Access Compliance Report

Public Rights-of-Way

(Curb Ramps)

Intersection ID: 3544	Main Street: VOLUSIA_CT	Cross Street: WEAVERS_GLENN_PL	Location:	N
ADA ID: 746D0BBB9DA9	Ramp Type: PerpDiag	Initial Pass/Fail: Fail	Overall Compliance: No	Severity Score: 50

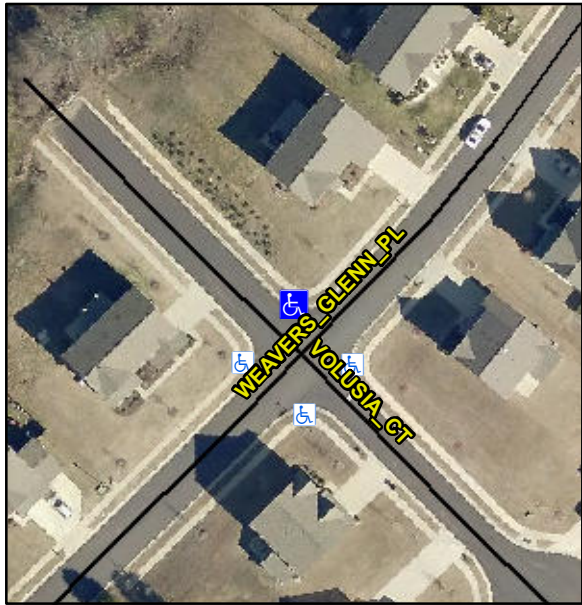
Codes/Mitigation Info/Possible Solution			Field Measurements/Component Compliance					
	Possible Solutions:		Compliance	Description	Data	Compliance	Description	Data
	Remove & Replace Curb Ramp With Two New Directional Ramps or Equivalent.		N/A	Ramp Length (in)	46.0	No	Ramp Slope (%)	12.8
			Yes	Ramp Width (in)	59.0	No	Ramp XSlope (%)	8.2
			N/A	Flare Type LT	N/A	N/A	Flare Type RT	N/A
			N/A	Flare Slope LT (%)	N/A	N/A	Flare Slope RT (%)	N/A
			N/A	Flare Traversable LT?	N/A	N/A	Flare Traversable RT?	N/A
			N/A	Landing Length (in)	N/A	N/A	DWS Provided?	N/A
			N/A	Landing Width (in)	N/A	N/A	DWS Contrast?	N/A
			N/A	Landing Slope (%)	N/A	N/A	DWS Length (in)	N/A
			N/A	Landing X Slope (%)	N/A	N/A	DWS Full Width?	N/A
Surveyor Notes:			N/A	Landing Curb? (Y/N)	N/A	N/A	DWS Offset (in)	N/A
N/A			N/A	Shared Landing?	N/A			
PROW/ADA:			N/A	Gutter Ponding?	N/A	N/A	Gutter Slope (%)	N/A
Not Found, R304.2.2, R304.5.3			N/A	Gutter Lip Ht (in)	N/A	N/A	Gutter X Slope (%)	N/A

N/A	Painted X Walk1?	No	N/A	Painted X Walk2?	No
				X Walk 1 Direction	To SW		X Walk 2 Direction	To SE
			N/A	X Walk 1 Width (in)	N/A	N/A	X Walk 2 Width (in)	N/A
				X Walk 1 Slope (%)	0.3		X Walk 2 Slope (%)	5.6
				X Walk 1 X Slope (%)	7.8		X Walk 2 X Slope (%)	5.4
			N/A	Ramp inside XWalk1?	N/A	N/A	Ramp inside XWalk2?	N/A
				Road Slope (%)	6.7	N/A	Clear Space?	N/A
				Road X Slope (%)	0.9	N/A	Clear Space to XWalk (in)	N/A
			N/A	Any Obstructions?	N/A	N/A	Storm Grate/Utility Hazard?	N/A
				Obstruction Type			Storm Grate/Utility Type	
					N/A			N/A
						Yes	Surface Condition? (G/P)	Good
Total Cost:		\$ 3200.00						
Street 1 Name		VOLUSIA CT						
Stop Condition-Street 2		StopSign						
Street 2 Name		WEAVERS GLENN PL						
Stop Condition-Street 1		None
